DESIGN REVIEW COMMITTEE

February 21, 2024 6:00 PM

DEPARTMENT OF PLANNING AND ZONING
PLANNER'S REPORT

DATE:	February 15, 2024	Key:	
TO:	Tonya Hutson	Compliant:	✓
FROM:	Lynn Patterson	Not Compliant:	✗
RE:	Design Review – 551 Lake Drive – Addition and Front Remodel	Incomplete:	✋
		Not Applicable:	⊘

As Built Rear Elevation Garage Door 1/4" = 1'-0"

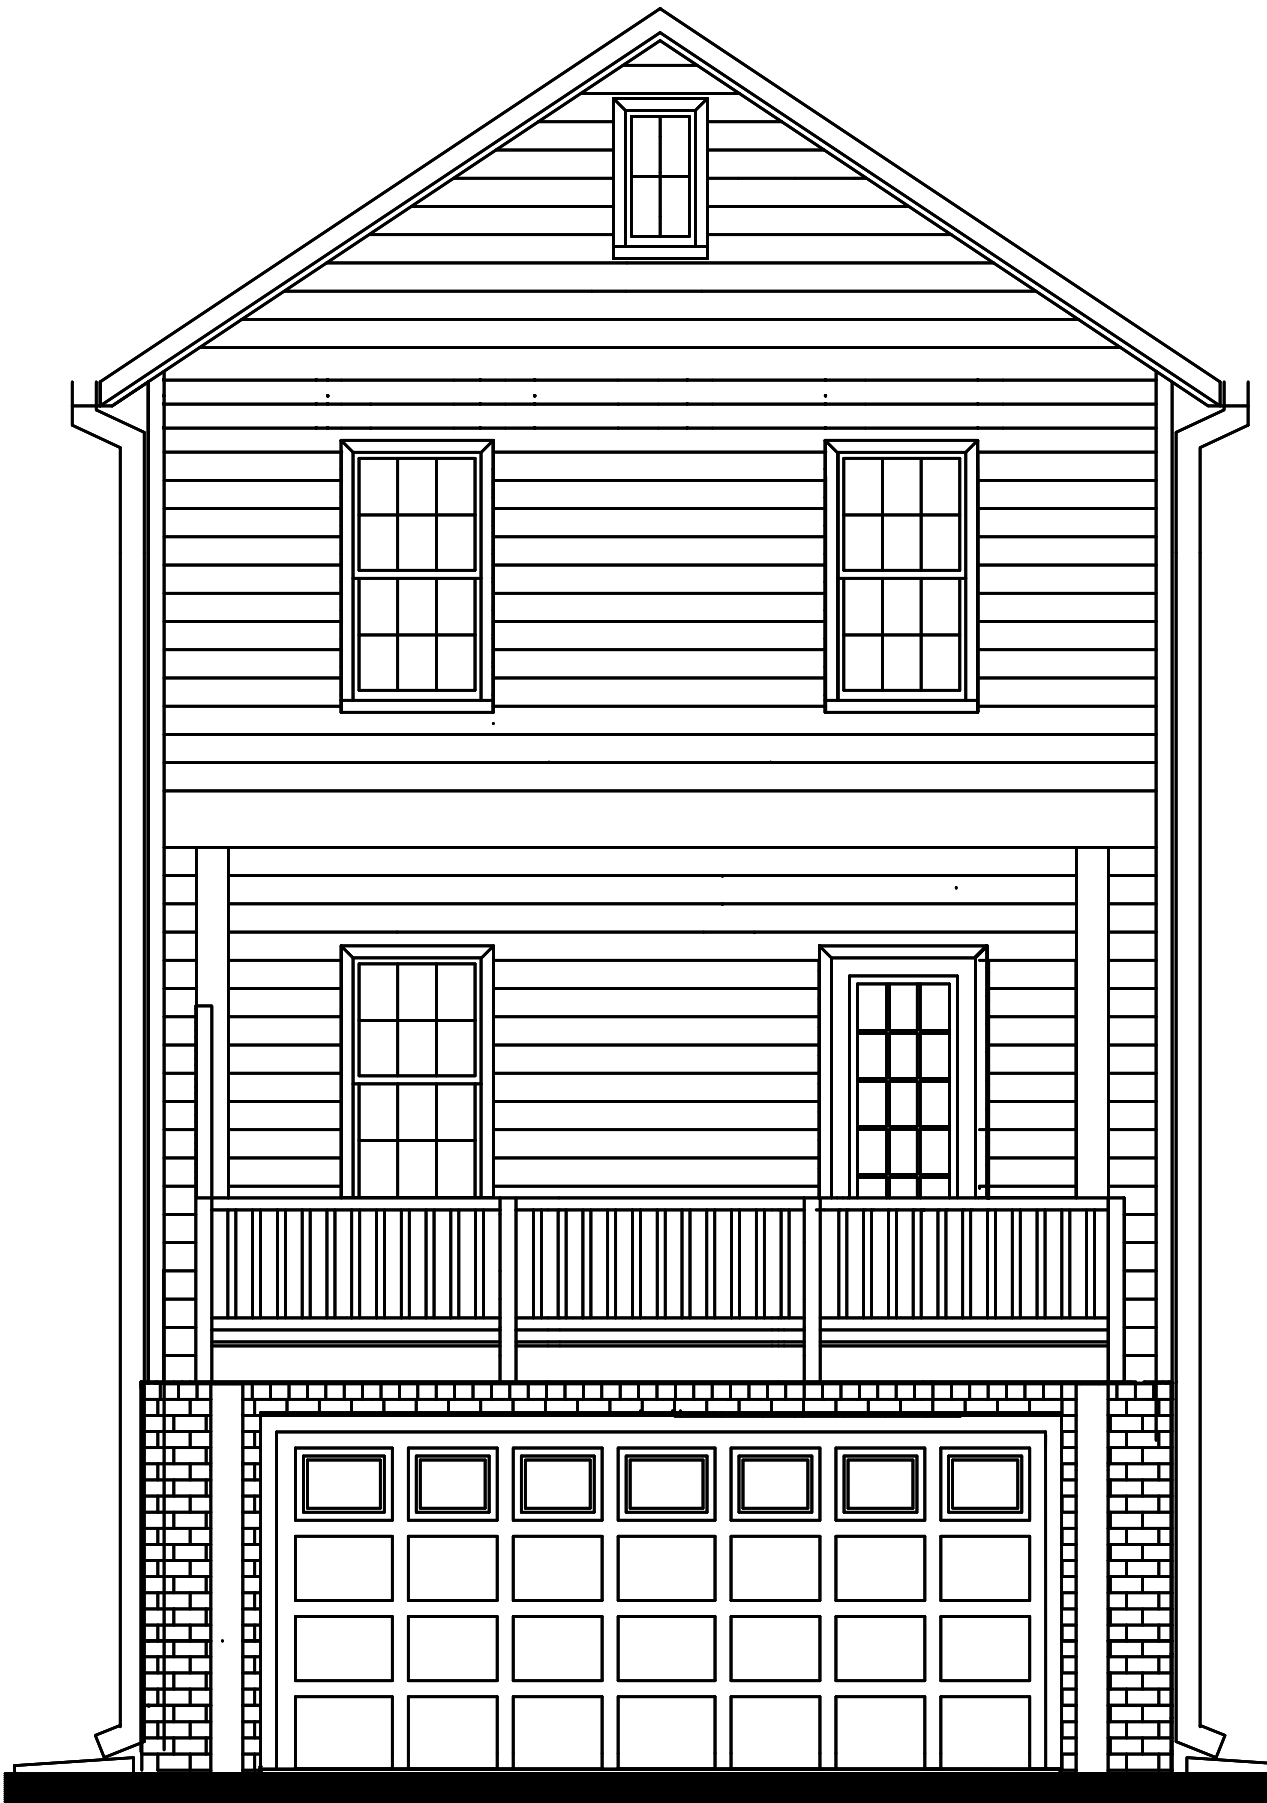
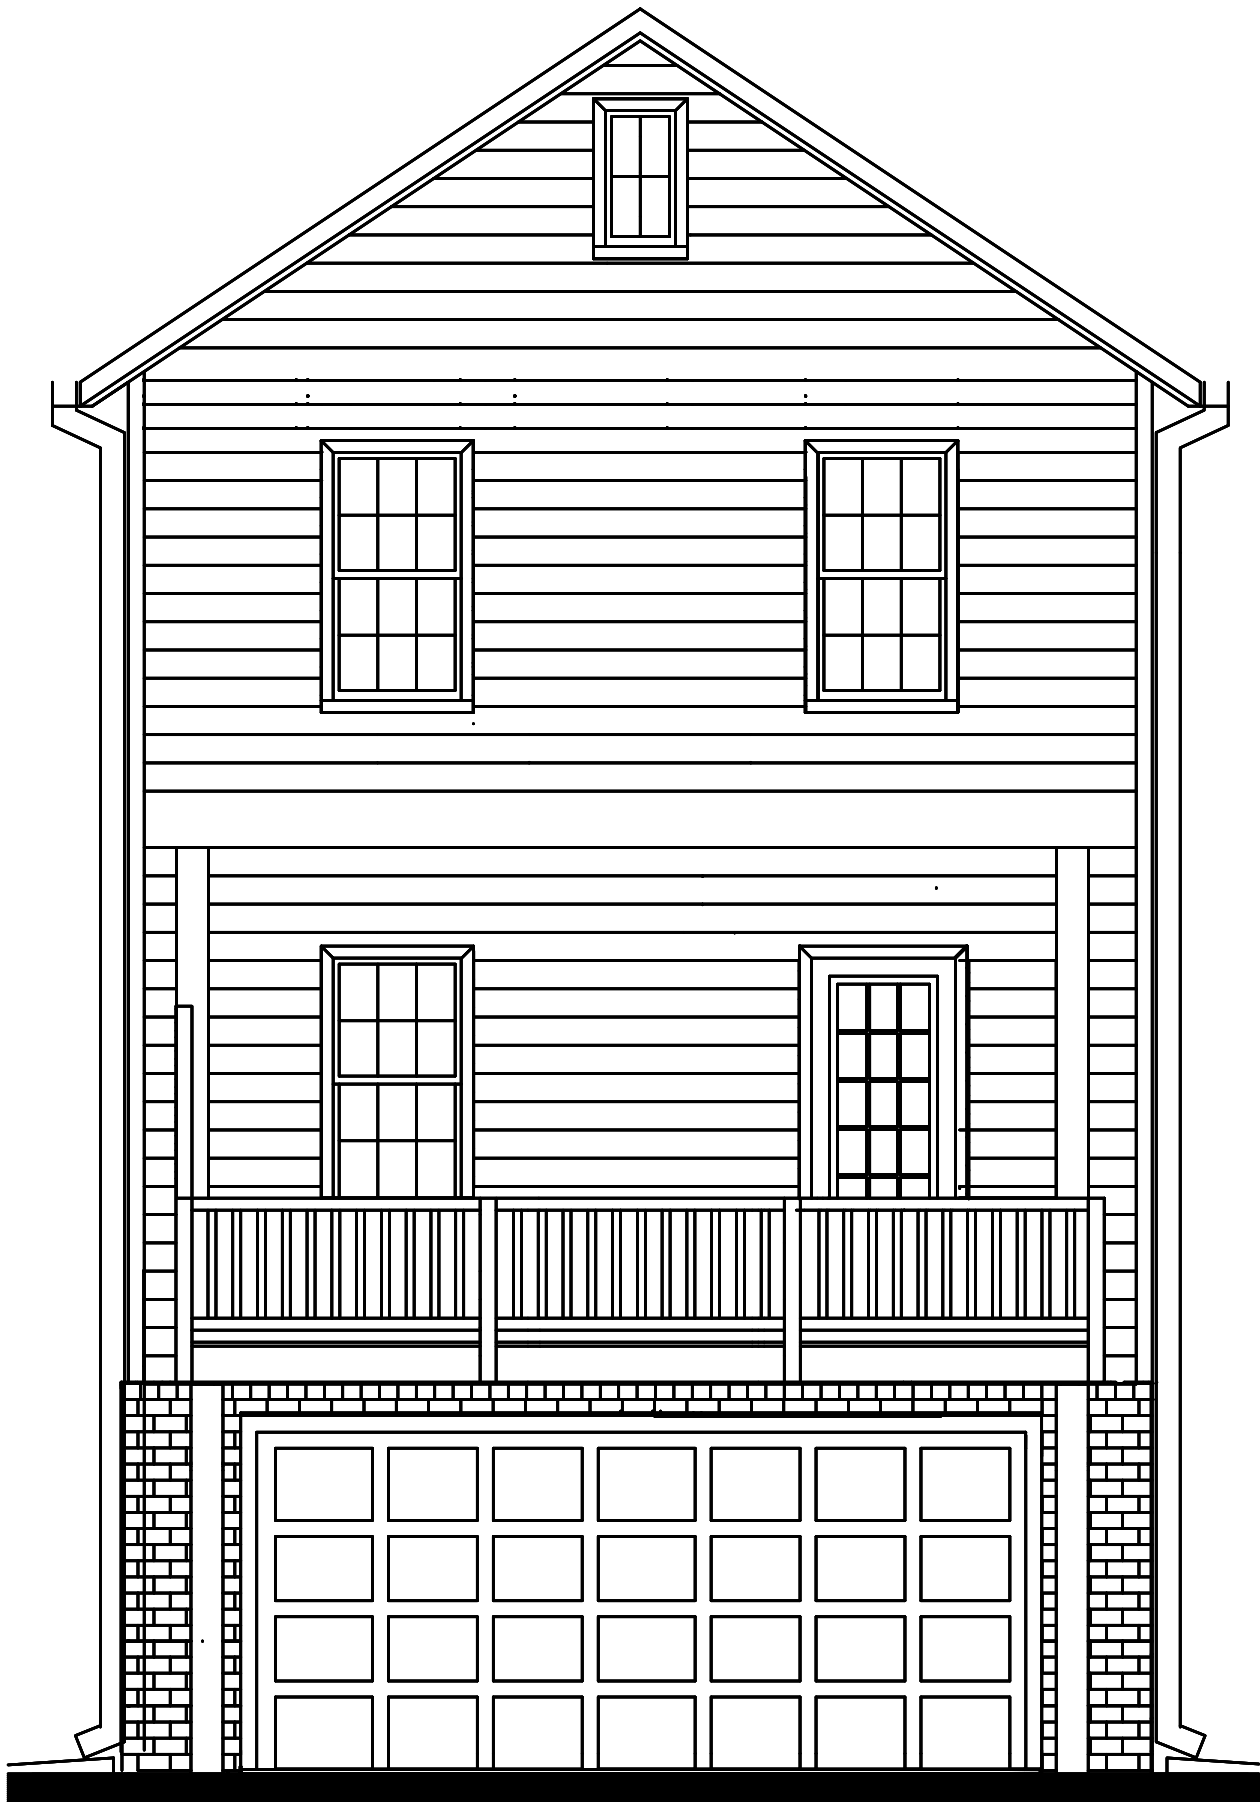
- The windowless garage doors should be shown on the as-built plans. Garage doors with windows were approved, solid doors were installed.
- Update the entry-door pediments to the As-Built, and show what will be changed on the redlines. The red lines should be similar to the approved elevations.

- **The as-built still does not show the proper side elevation for units 11 and 14.**
- **Shake siding has been added to Units 11 and 14; there is no detail for the sides of the bumpout / cantilever portion.**
- **The as-built rear garage door elevation shows windows in the garage doors. No windows are present in the garage doors as installed.**
- **The pediments shown on the as-built are not as constructed and the proposed pediments are not similar to the approved elevations.**

- 10: Garage doors without windows. Original plans indicated windows, the installed doors do not have them. The change is acceptable, must indicate on the as-built plans.
